Revised estimate - Water supply to Ganjam town

Water supply to Ganjam including the Gumbaz.

These papers relate to the revised scheme of water supply to Ganjam and the Gumbaz from a source independent of Seringapatam.

Scheme of water supply
to Gangam and the Gumbaz, from
a source independent of Serungapattan

SERINGAPATAM GUIDE MAP.

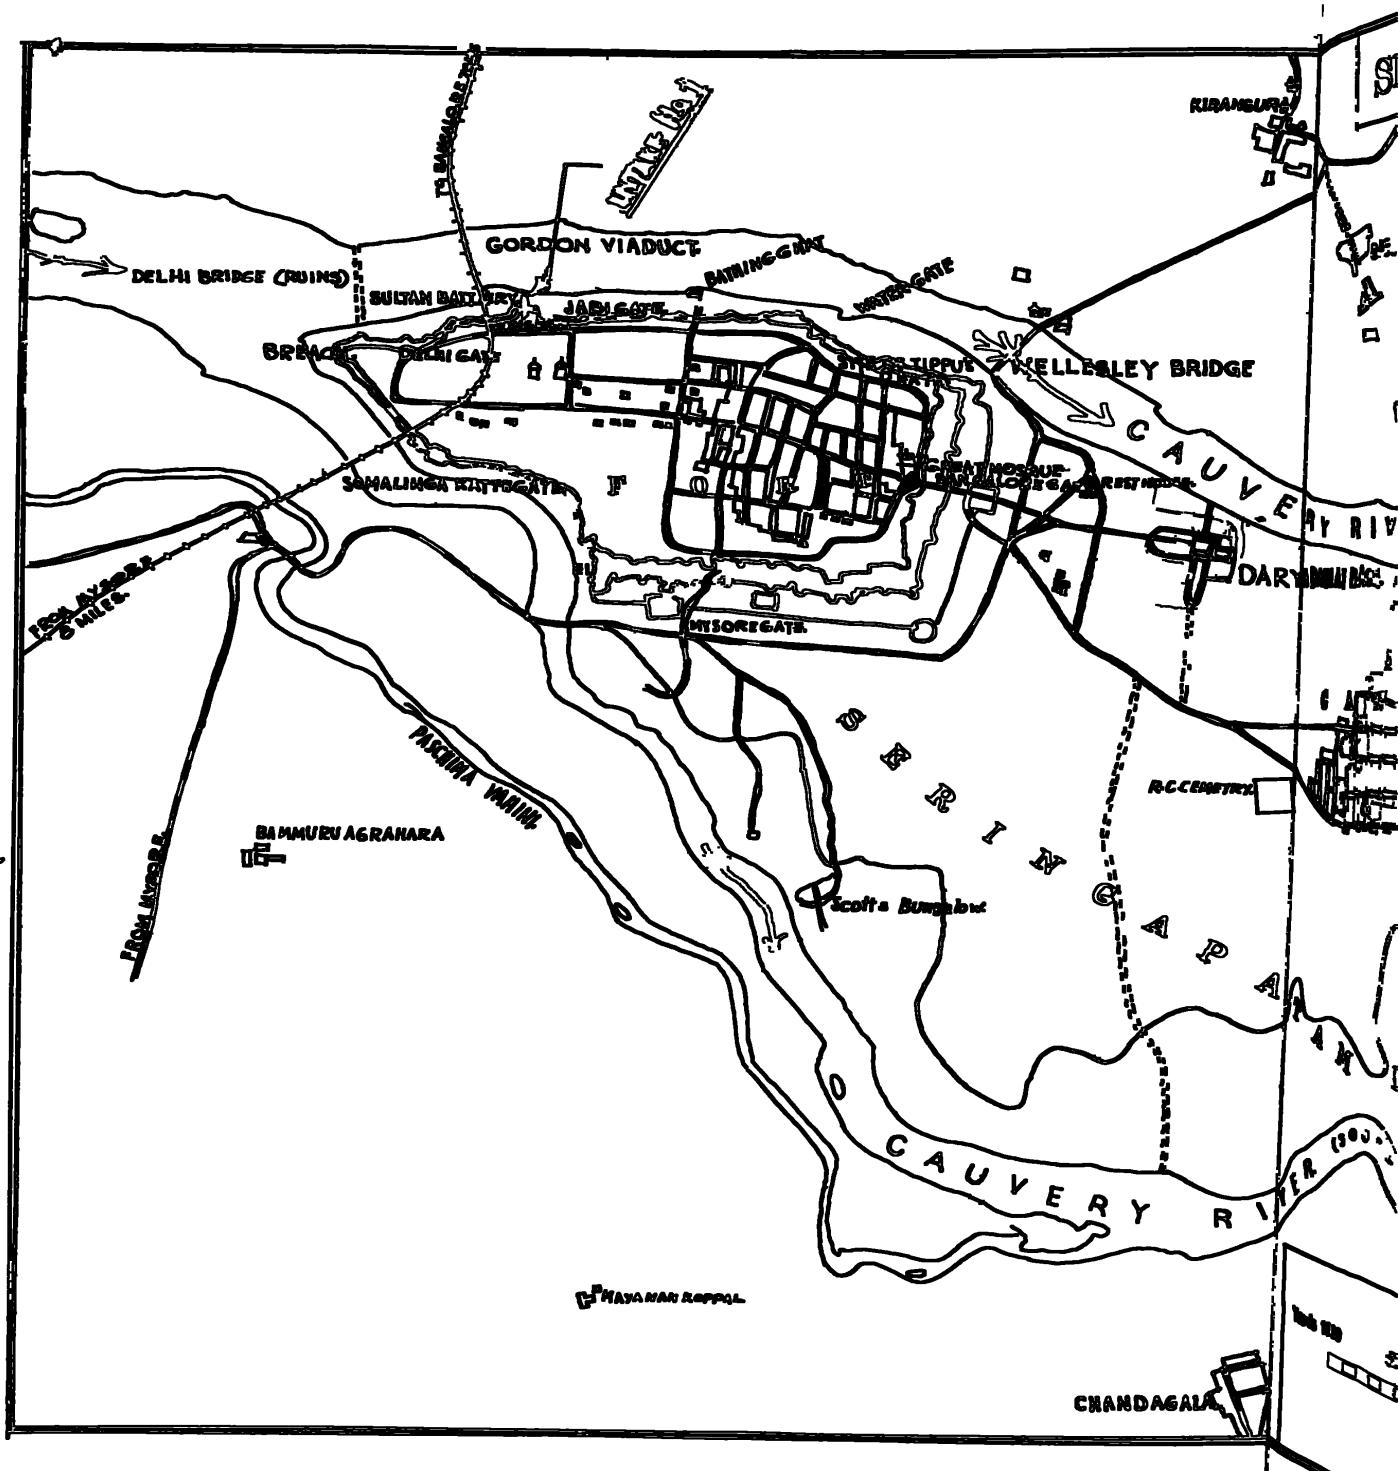
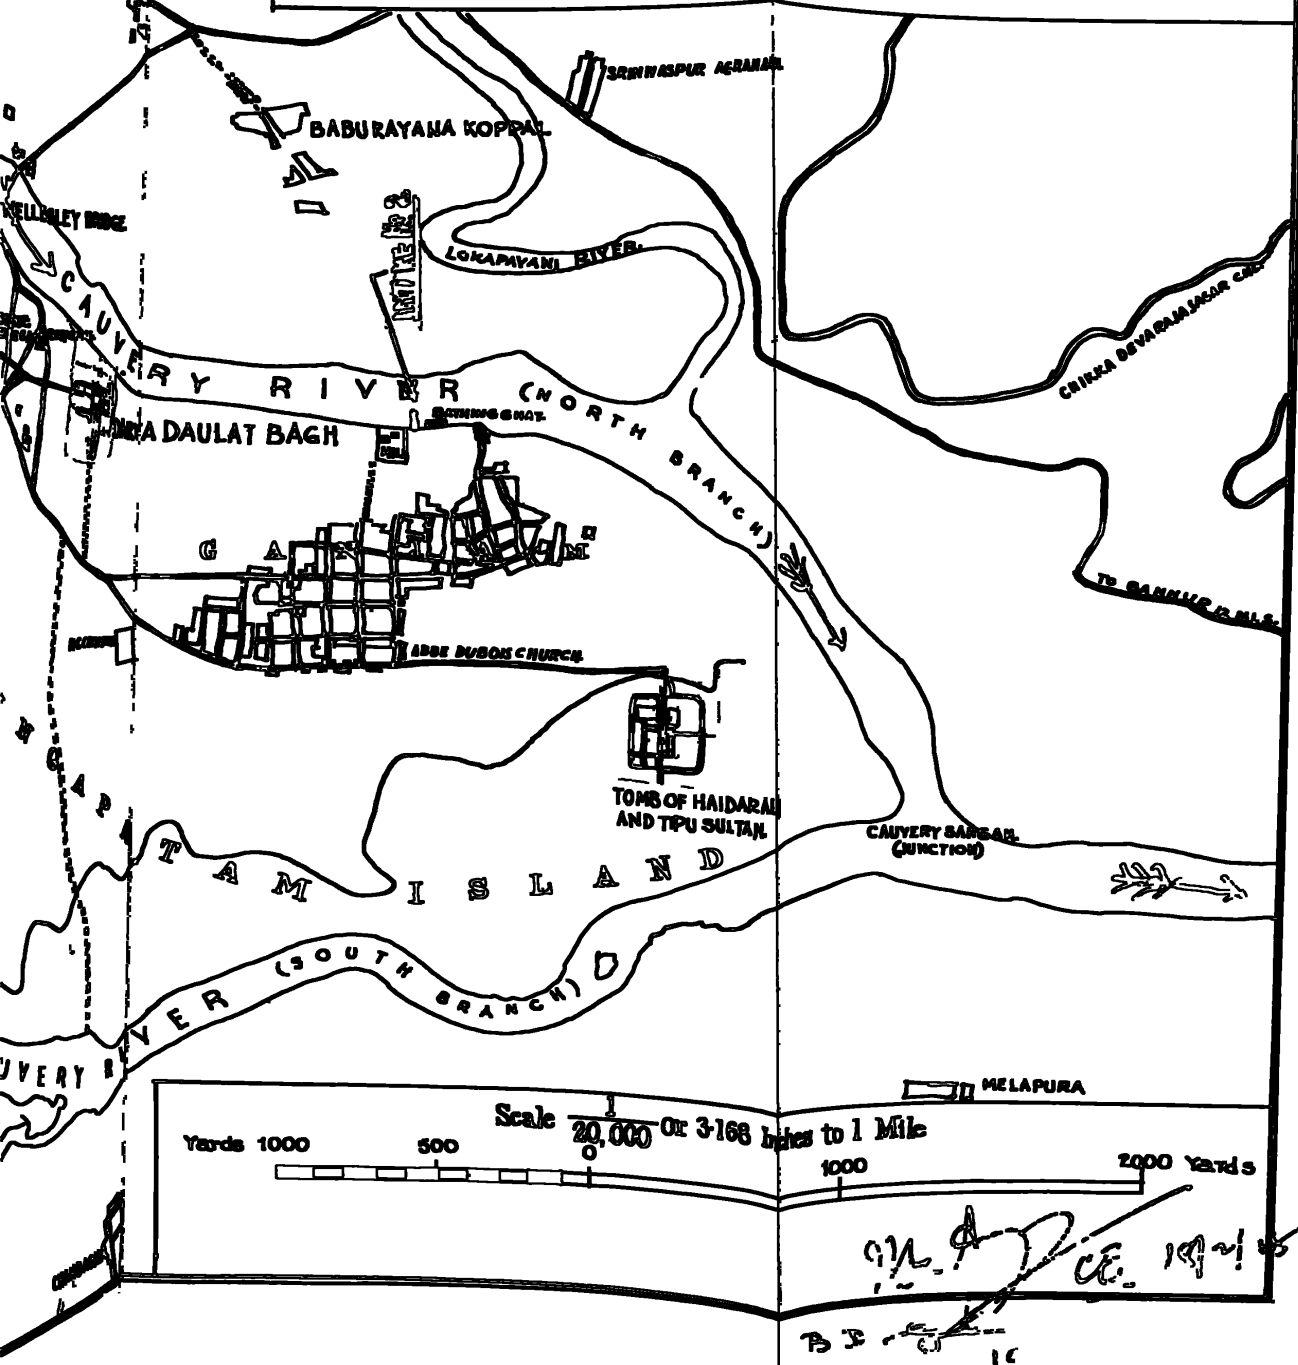
From the examination of the map, it will be seen that between intakes No.1 and No.2, sullage faecal matter and street sweepings all are ^{bound} ~~likely~~ to be washed into the river. ~~Intake No.1~~ Intake No.1 being on the upstream side of all these contaminations, has to be preferred, even if it costs more, for a water supply scheme.

The Pump House situated at intake No.1. is well protected by the Fort wall and it would be a pity to choose site No.2 in preference to site No.1. A break down, due to floods, of a water supply during the rains, has to be prevented.

It can be seen from the map that the drainage of the whole town of Seringapatam gets into the river between these two intakes. By locating the water supply pump of Ganjam in the Seringapatam Pumping Station i.e., in the intake No. 1 there are some special advantages which are enumerated below -

- 1). There will be no necessity of employment of a separate trained mechanic to supervise the pumping, filtration and chlorination for Ganjam water supply as the one employed for Seringapatam water supply will look after this work also.
- 2). Though the pumps of Ganjam and Seringapatam water supplies are of different heads, the Ganjam pump can be used for Seringapatam water supply in case of emergency. So, the Ganjam pump may be considered as a standby to Seringapatam pump.
- 3). There will be the saving of cost of building protective works which will be required if the Ganjam water supply pump and filter have to be erected at the intake No. 2.
- 4). The existing mains can serve future extensions of Ganjam and Seringapatam which must be only towards the Bangalore - Mysore road.

I strongly recommend intake No.1 for water supply for both Ganjam and Seringapatam. Pumping for fig cultivation can be made at intake No.2.
